777

Service Bulletin

Number: 777-53A0075
Original Issue: January 14, 2015
Revision 1: December 14, 2015
ATA System: 5380

SUBJECT: FUSELAGE - Section 48 - Station 2370 Pivot Bulkhead Forward Outer Chord -
Inspection and Repair

FIGURE 15: LEFT SIDE - STA 2370 PIVOT BULKHEAD FORWARD CHORD - REPAIR
(SHEET 8 OF 22)

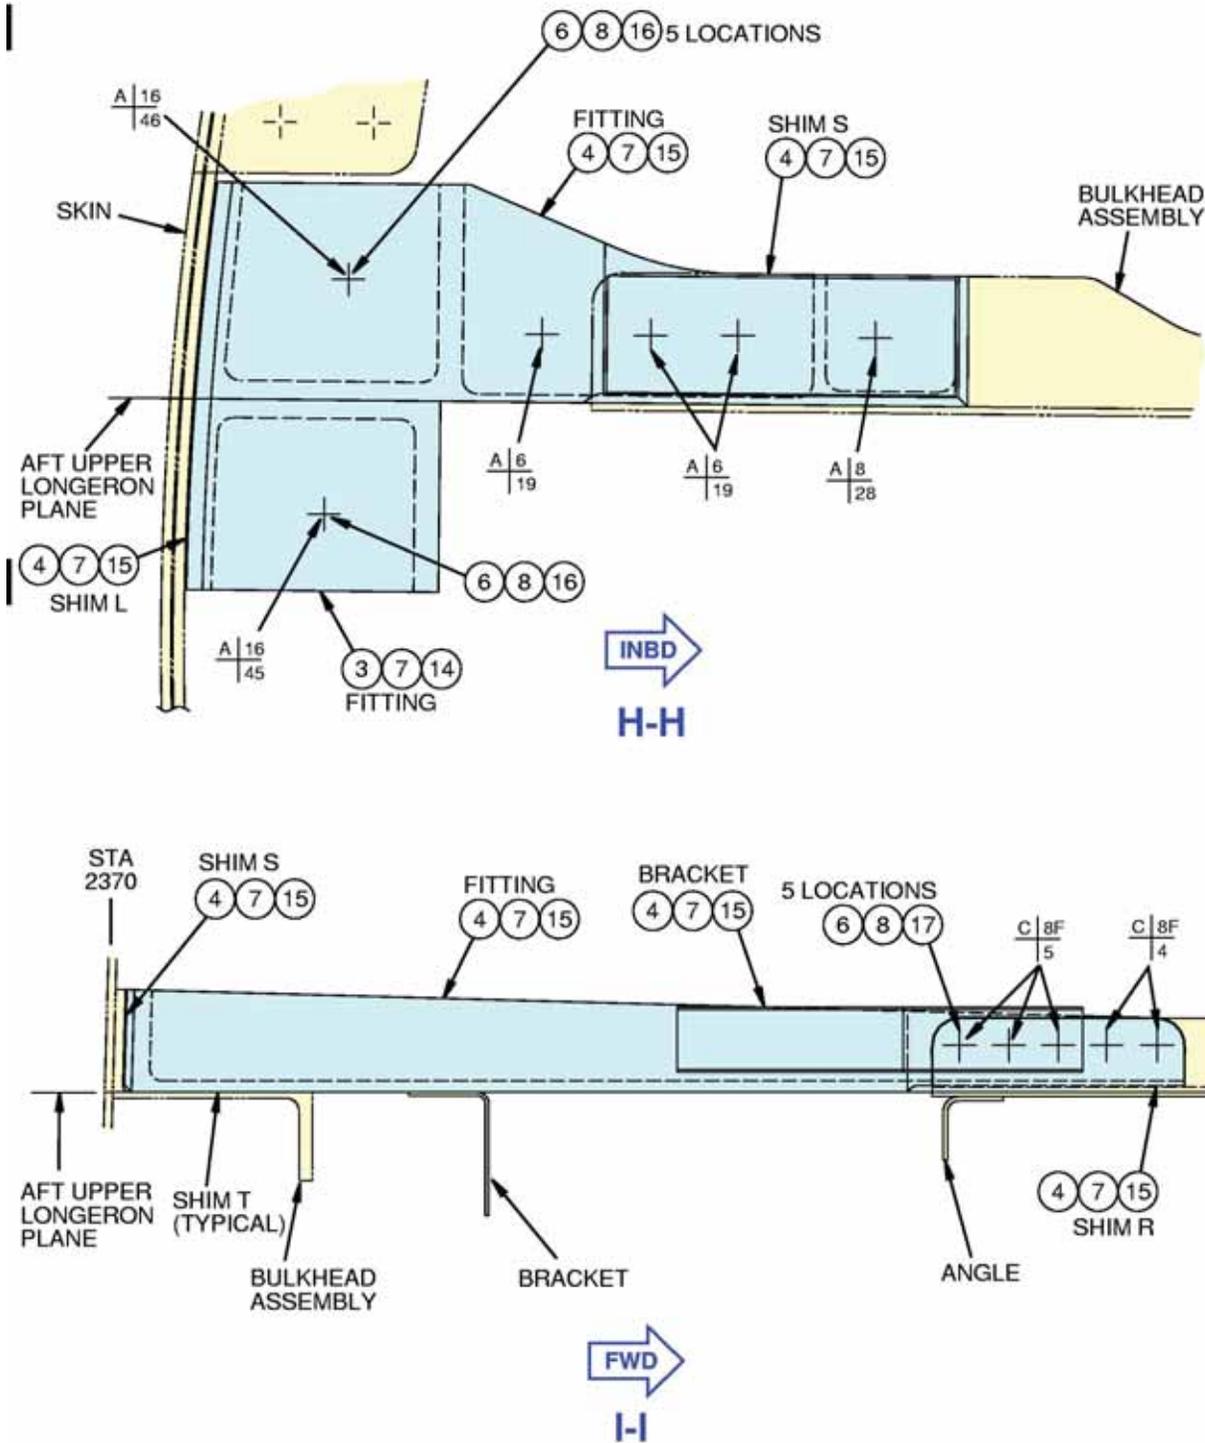
22. In Figure 15, Figure 16, Figure 17, Figure 18, Figure 21, Figure 22, Figure 23 and Figure 24, revised the illustrations, the step table and the fastener code table.

FIGURE 25: LEFT SIDE - STA 2370 SKIN PANEL REMOVAL
(SHEET 1 OF 4)

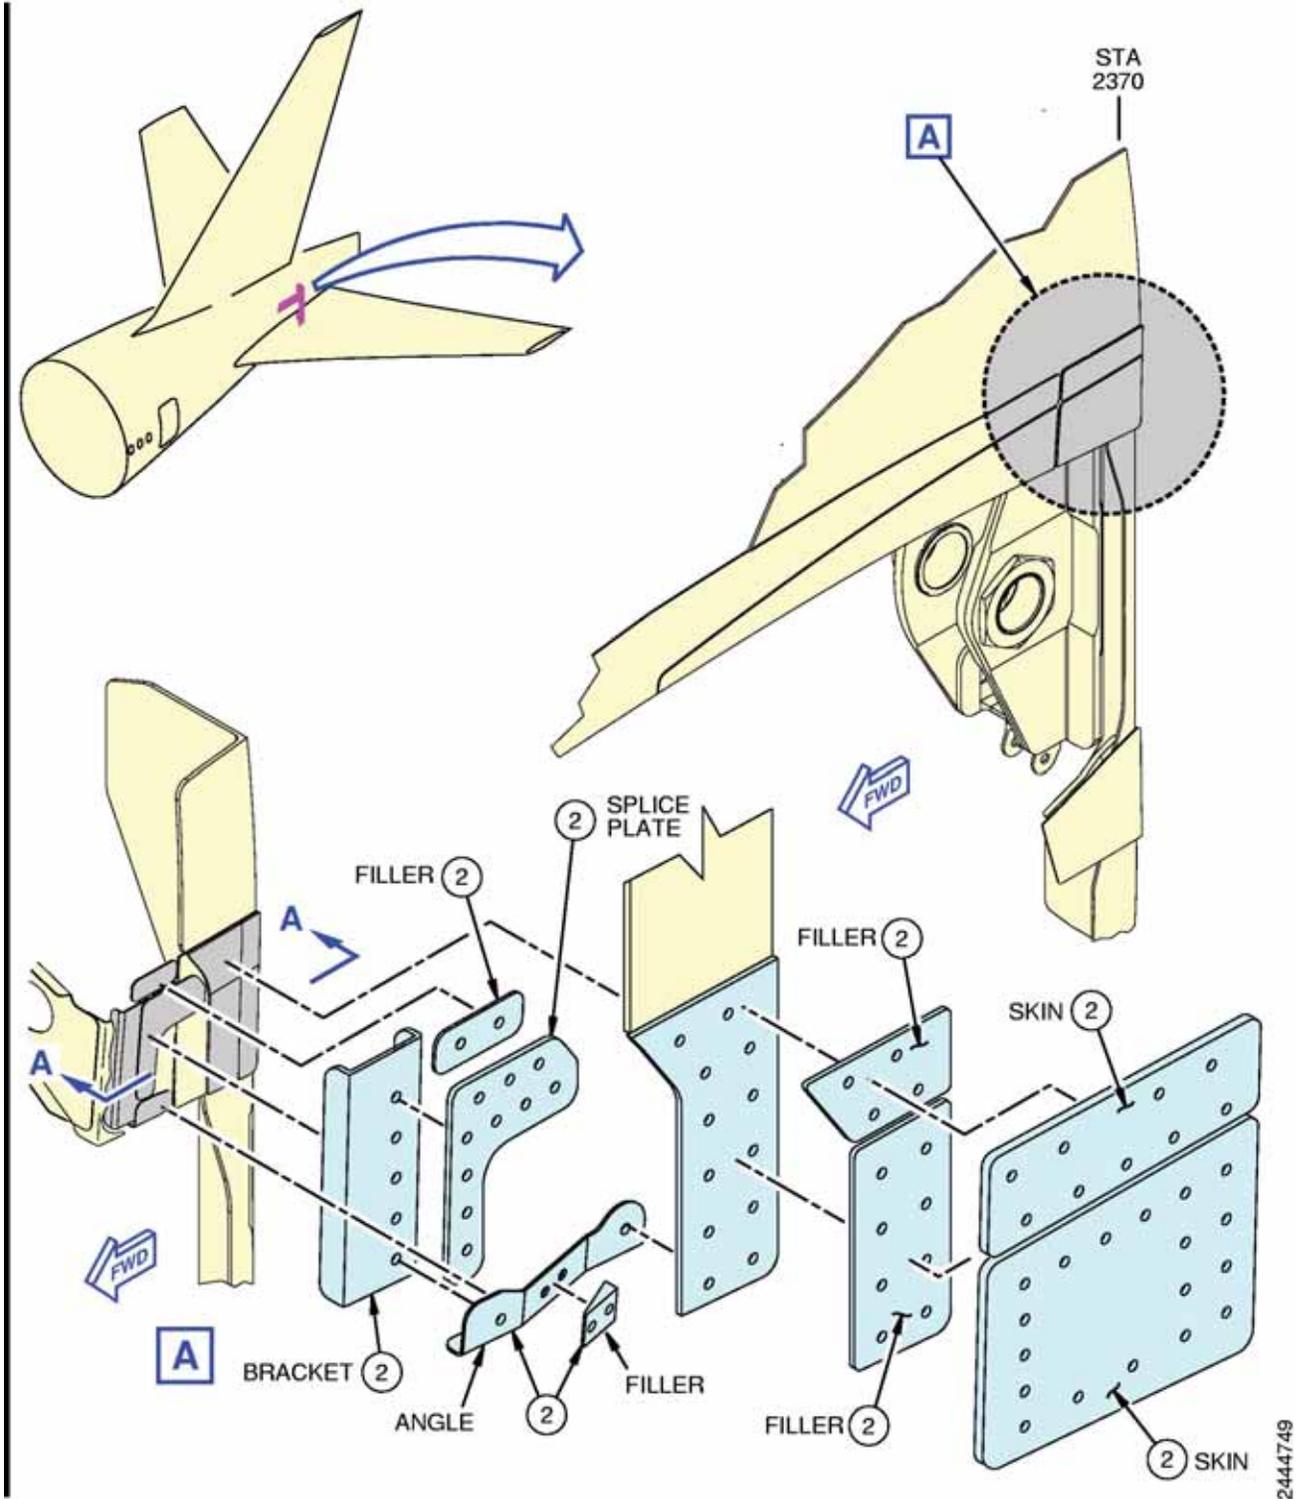
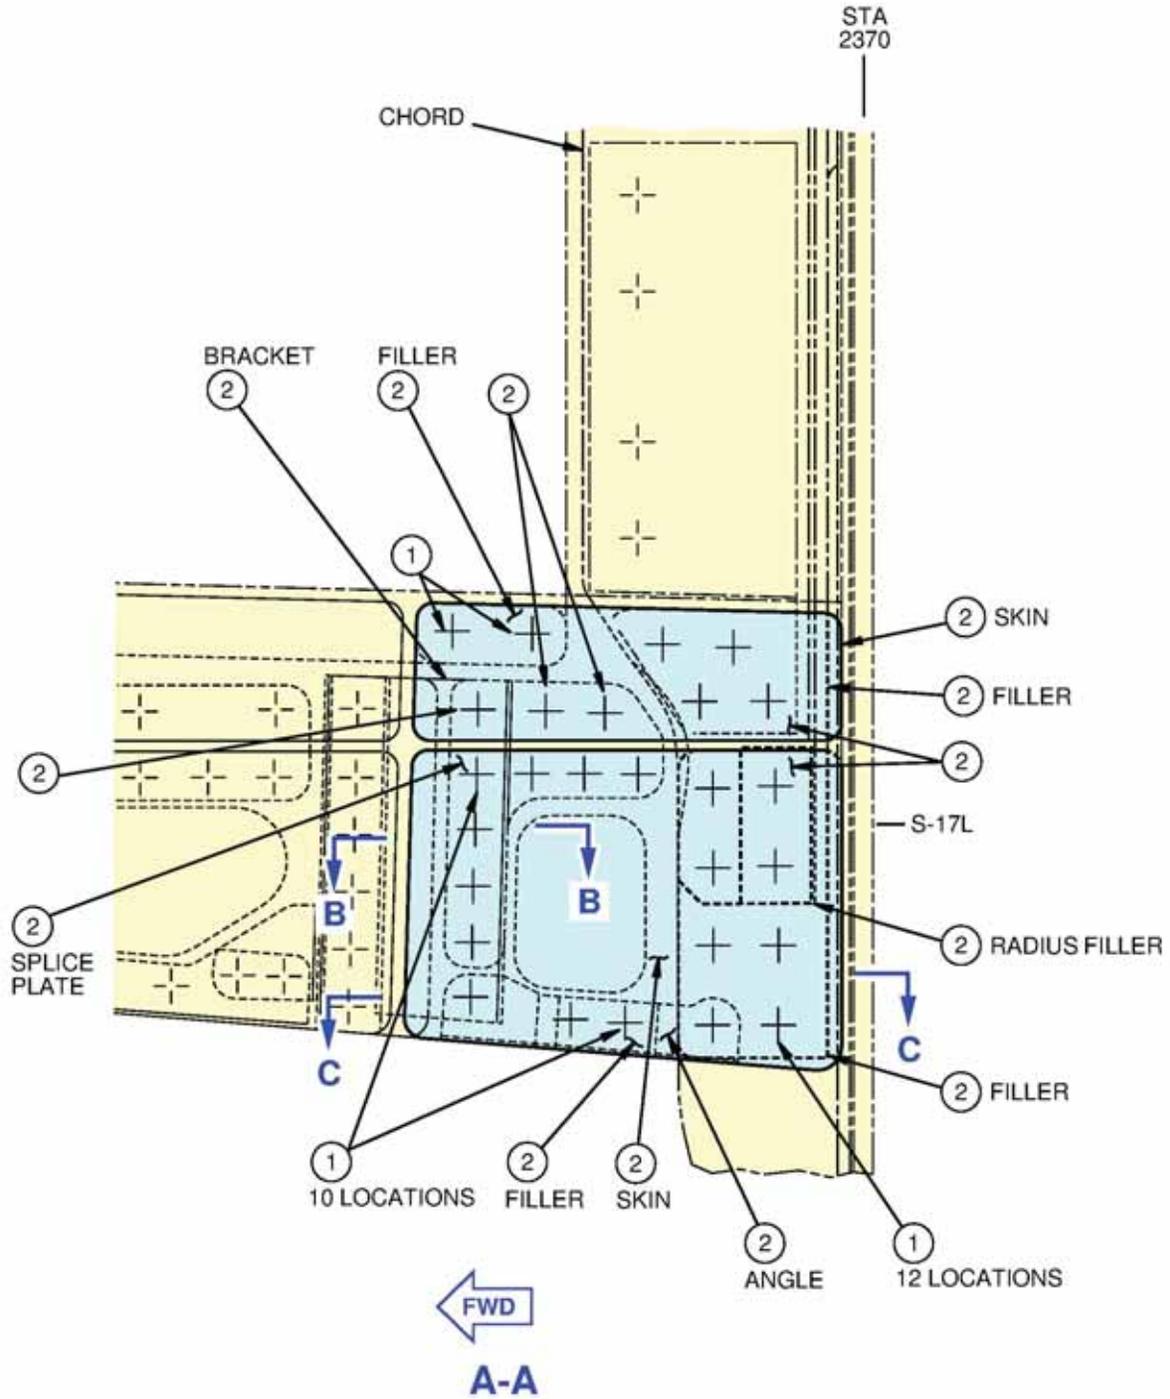
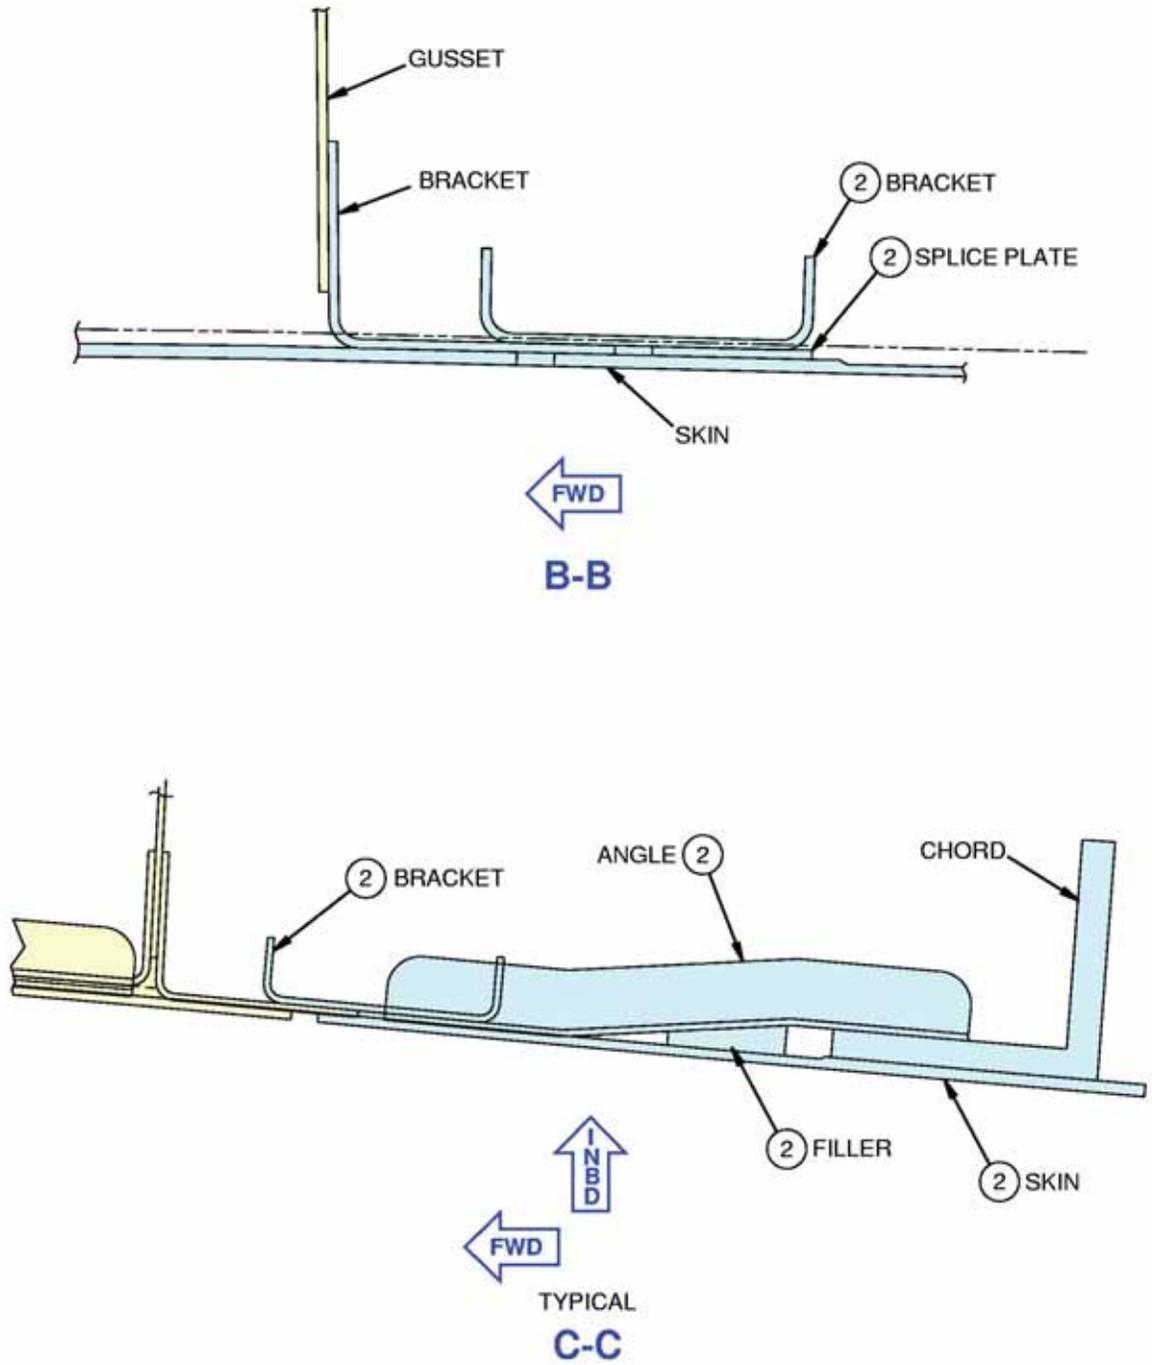
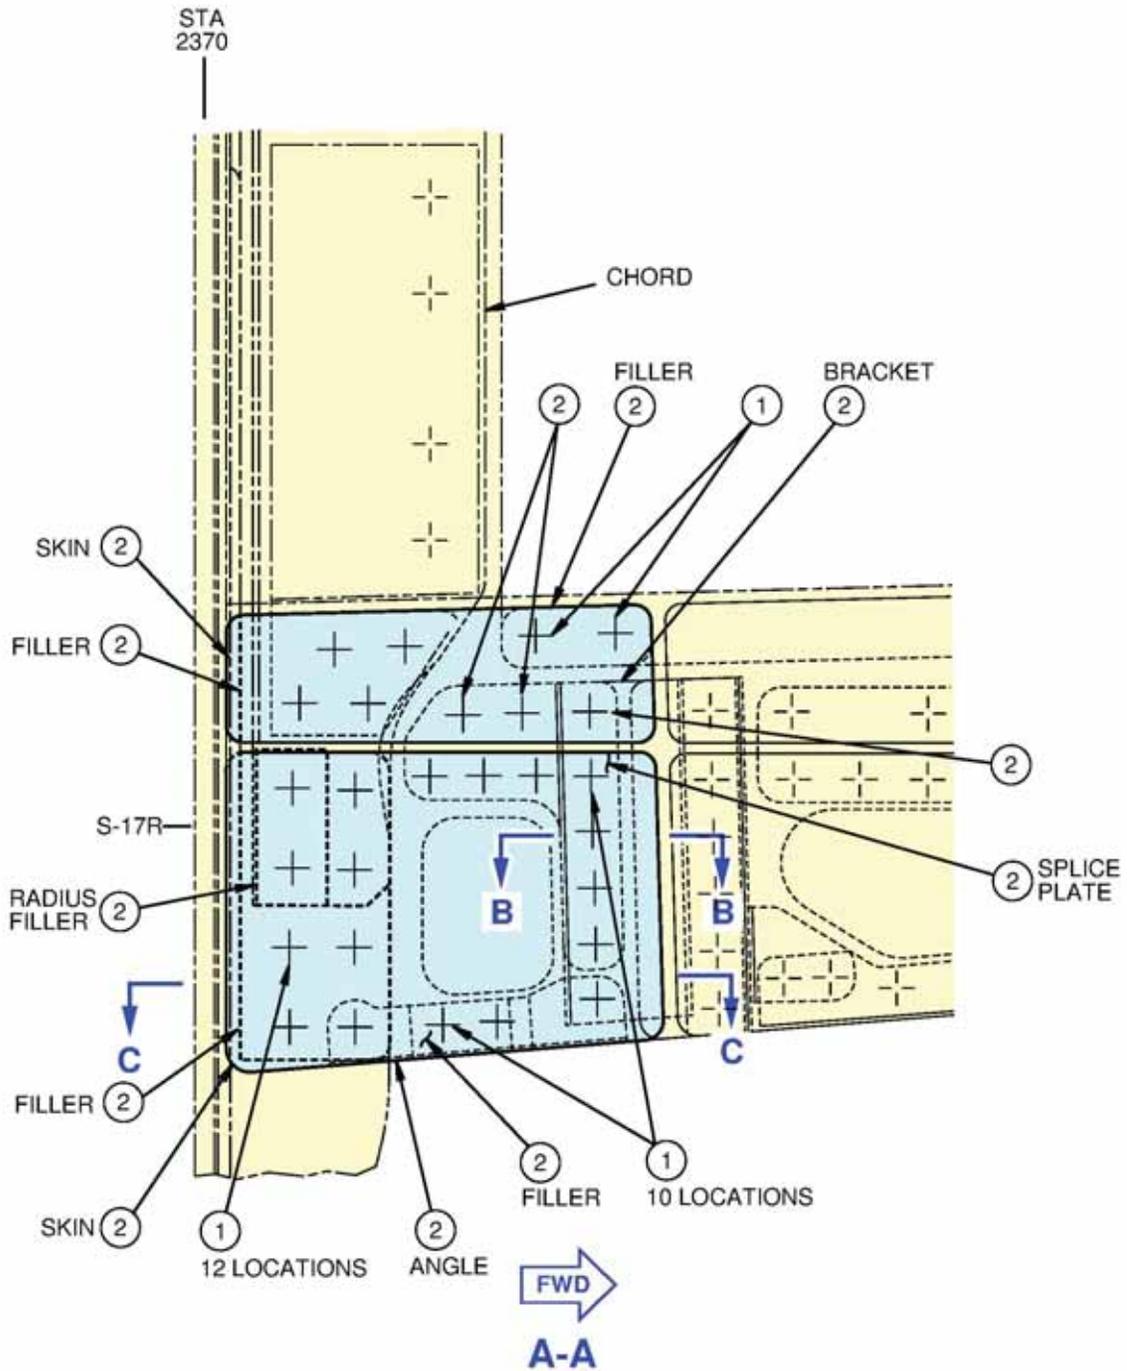
23. Added Figure 25 and Figure 26 to give instructions for skin panel removal after the small crack repair was installed.
24. In Appendix A, revised the table and the flag note, revised the logic diagram.
